ESP32-P4 Chip Revision v3.x

User Guide v1.0

This document describes differences between chip revision v3.x and previous ESP32-P4 chip revisions.

Figure 3-1. The label of ESP32-P4NRW16X

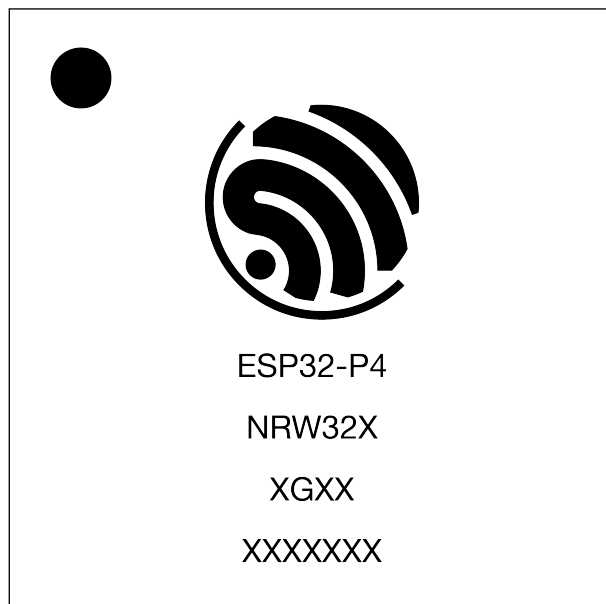
The figures above show the chip marking of chip revision v3.1: its manufacturing code is XGXX. For chip revision identification by chip marking, please refer to [ESP32-P4 Series SoC Errata](#).
